Official Transcript of Proceedings  
NUCLEAR REGULATORY COMMISSION

Title: Advisory Committee on Reactor Safeguards  
EPR Subcommittee

Date: November 19, 2009

6 U.S. EPR SUBCOMMITTEE

**One of Four Divisions of Main Steam Supply**

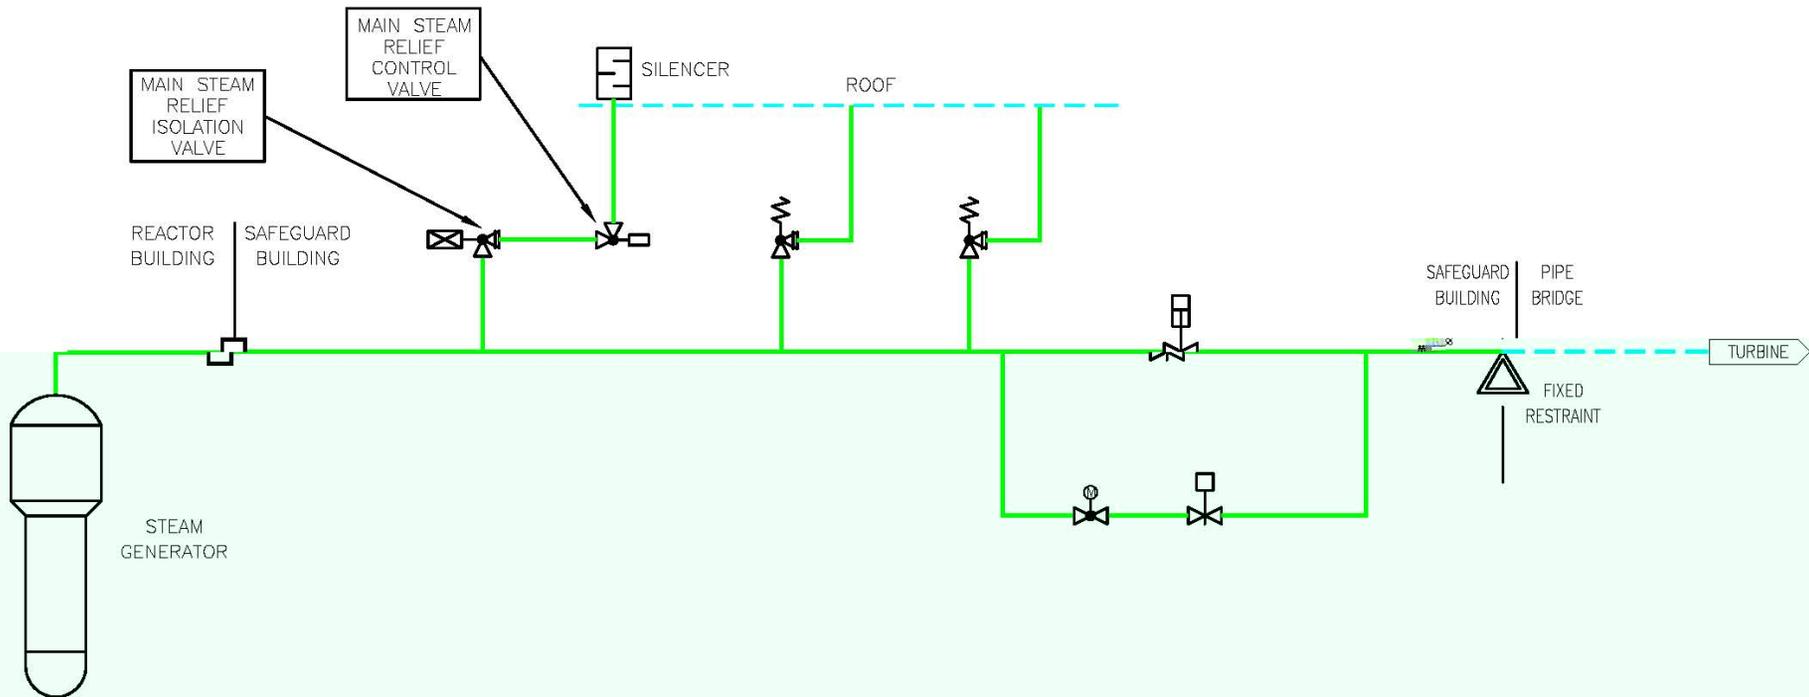
13 MEMBER STETKAR: I mean, do you know of  
14 any French plants -- I'm not familiar with the French  
15 plants. I'm familiar with the German plants and the  
16 German plants where they have the -- whatever you want  
17 to call it, the program cool-down mode, keep the  
18 control valve closed and the isolation valve open and  
19 throttle control valve open.

2 MEMBER STETKAR: -- the vast majority of  
3 the plants in the world operate with an open isolation  
4 valve and accept the minor leakage if any from  
5 coolant.

15 MEMBER STETKAR: Okay. Okay. And I  
16 understand now why it's -- because it is an MOV, I  
17 understand why it's -- why it's open. I'd still like  
18 to know if any operating plants in France, for  
19 example, have this configuration and what their  
20 experience might be.

21 Relative to this question, as you  
22 indicated, basically it's kind of the opposite way  
23 that you would normally see an atmospheric dump valve,  
24 if you wish, in an operating plant.

1 was to get the -- really the desired plant response  
2 that you want. If you did it the normal way you're  
3 basically going to have a slow response in the control  
4 valve because it's a motor-operated valve and it would  
5 be too slow to respond.

6 Typically in the operating plant you'll  
7 have an AOV as the control valve and you'll have an  
8 MOV for the isolation valve, and the AOV can respond  
9 very rapidly, and that's how you -- and that's how you  
10 manage your transient.

11 Here, again, with the MOV as the control  
12 valve, you couldn't get the response you wanted. So,  
13 that's really the reason why basically it looks  
14 backwards.

### Train 1 of 4

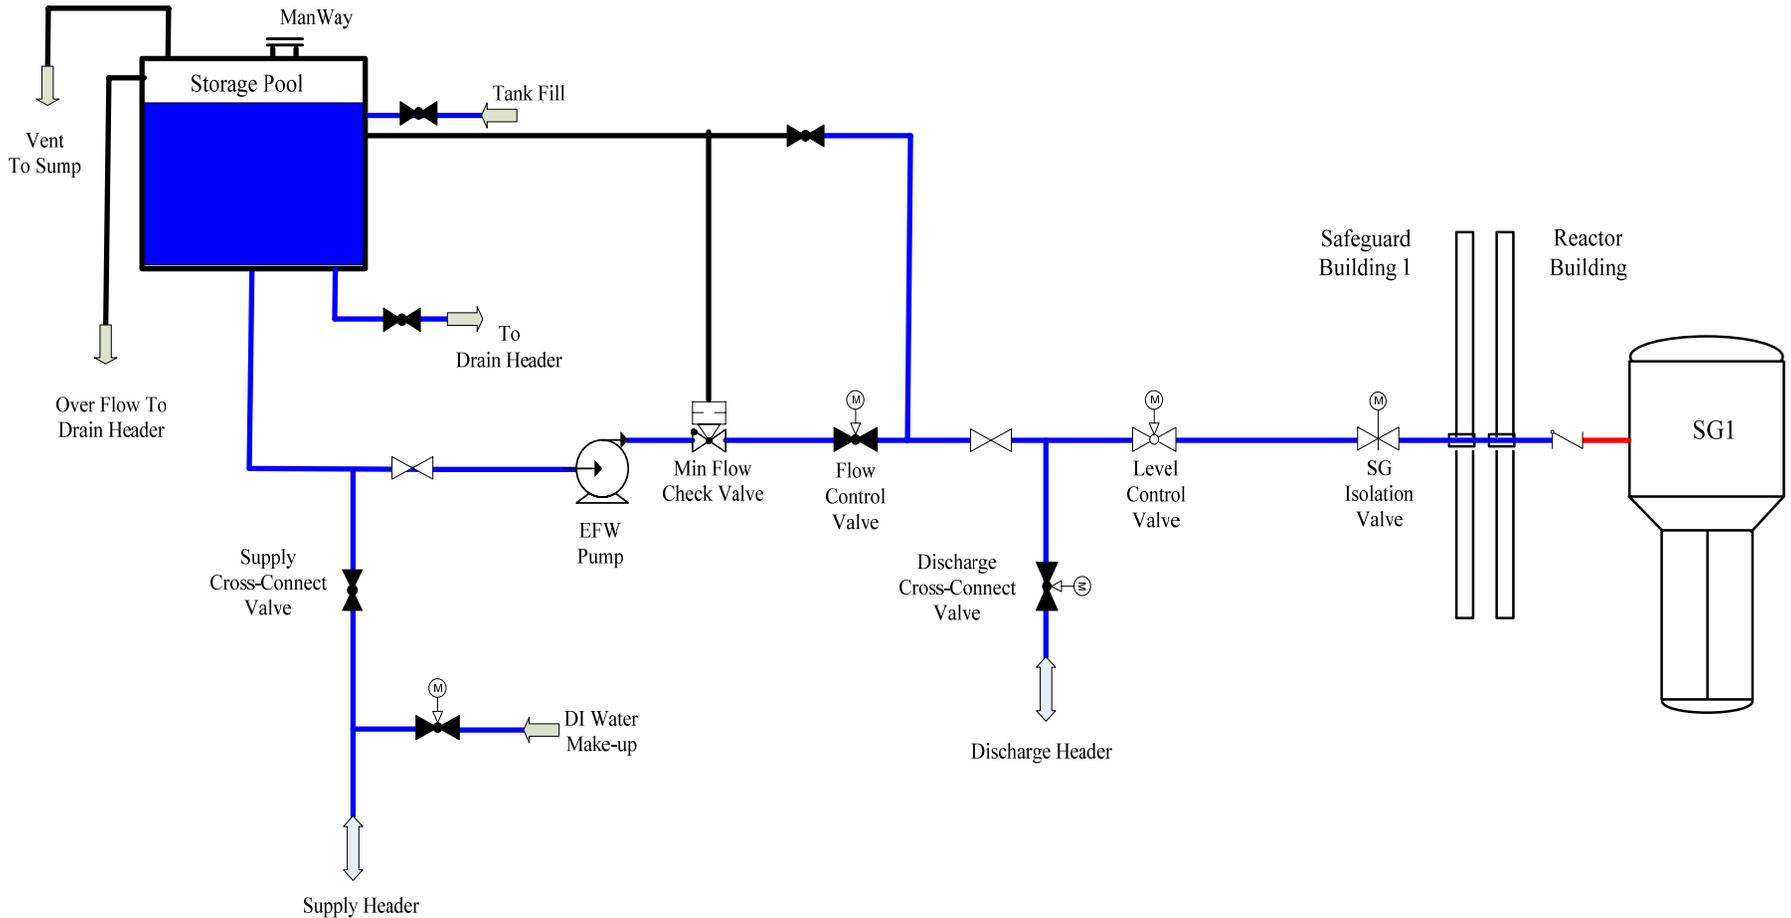
2 MEMBER STETKAR: The flow control valve is  
3 normally fully closed. Is that -- you show it closed  
4 on this drawing. Is that right?

16 The valve is positioned on its mechanical  
17 stop stand-by during normal plant operation which gave  
18 me the impression that it was at its open stop and  
19 another place it says the valves are closed.

### Cross Feed Example

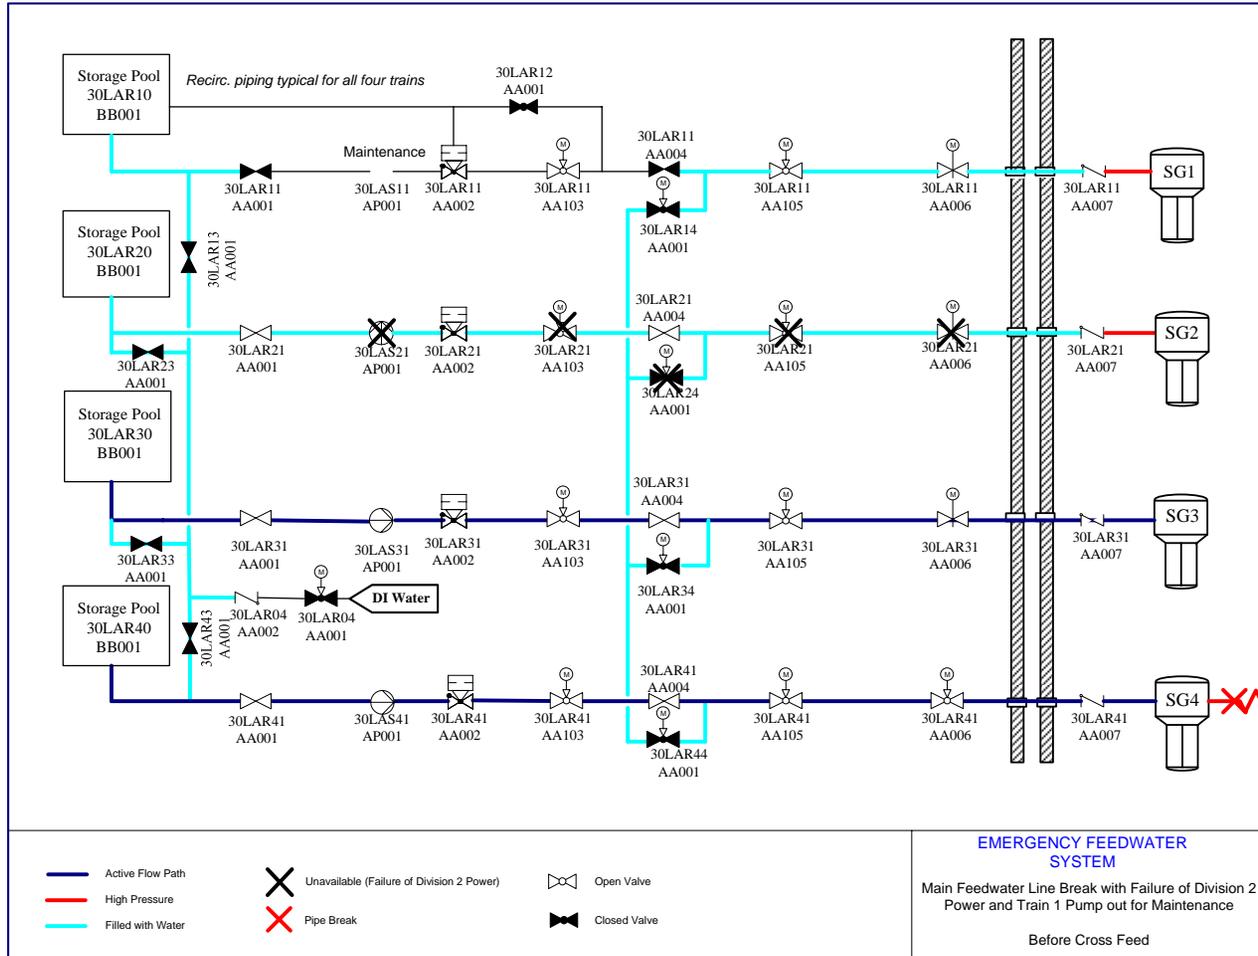
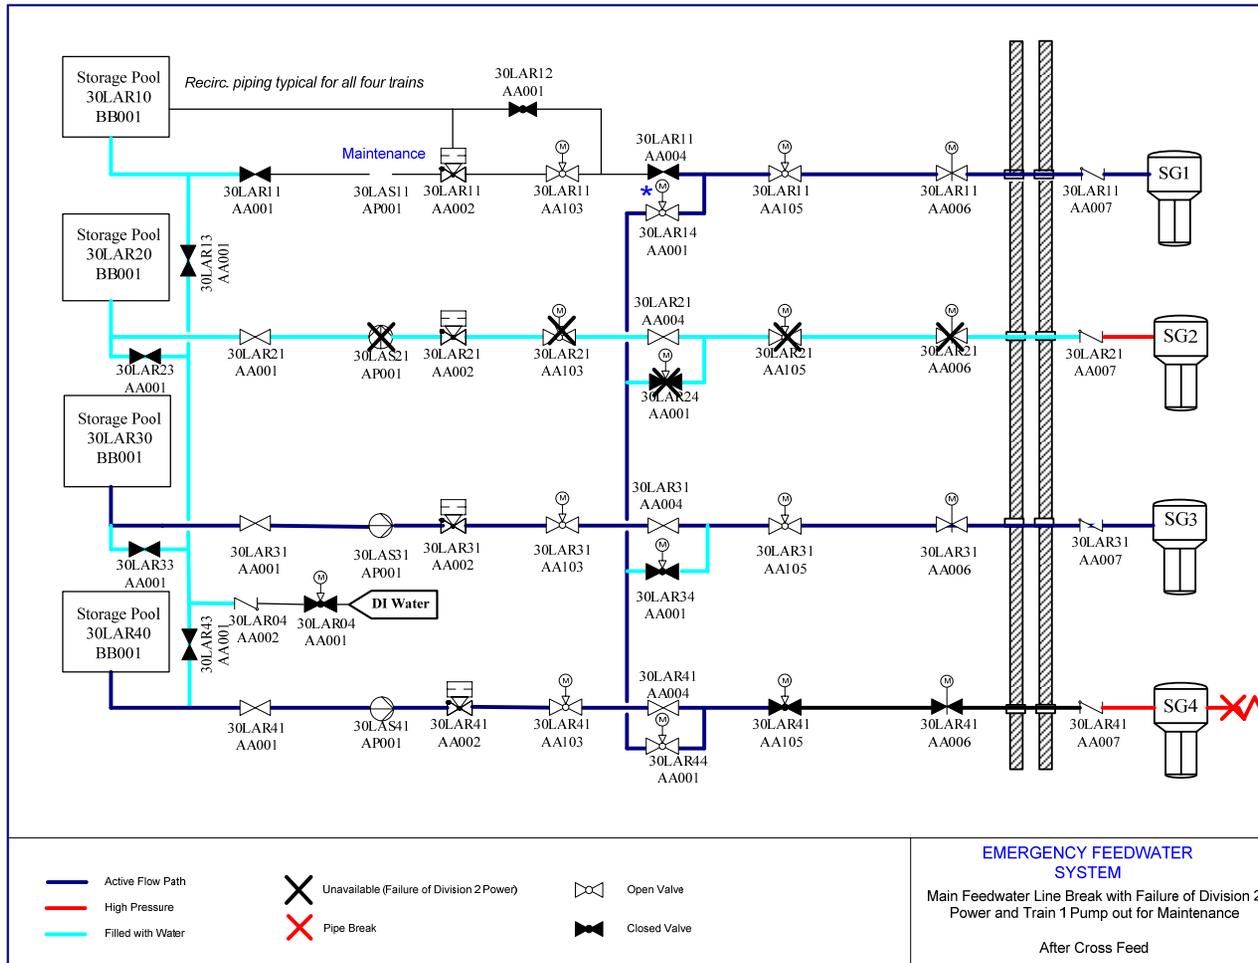
9 MEMBER STETKAR: I understand Chapter 15  
10 analysis and meeting all kinds of criteria, but in the  
11 real world, can I be -- can I remove post trip decay  
12 heat by feeding one and only one steam generator with  
13 one and only one emergency feedwater pump?

3 MEMBER STETKAR: Yes. In other words,  
4 suppose I only had one pump in the world, one  
5 emergency feedwater pump and I needed realistically to  
6 remove decay heat, how long could I do that with the  
7 available inventory in its respective storage tank?

8 And I'll pin you to the small of the two  
9 storage tanks. I'm trying to figure out a time window  
10 for how much time is available for the operators  
11 before they really need to open the cross-tie.

13 MR. McCUMBER: No. Let me clarify that,  
14 too. Chapter 15, using the ANSI standard for decay  
15 heat, you know, if you go to more of a best estimate  
16 PRA type of decay heat, one pump can do it.
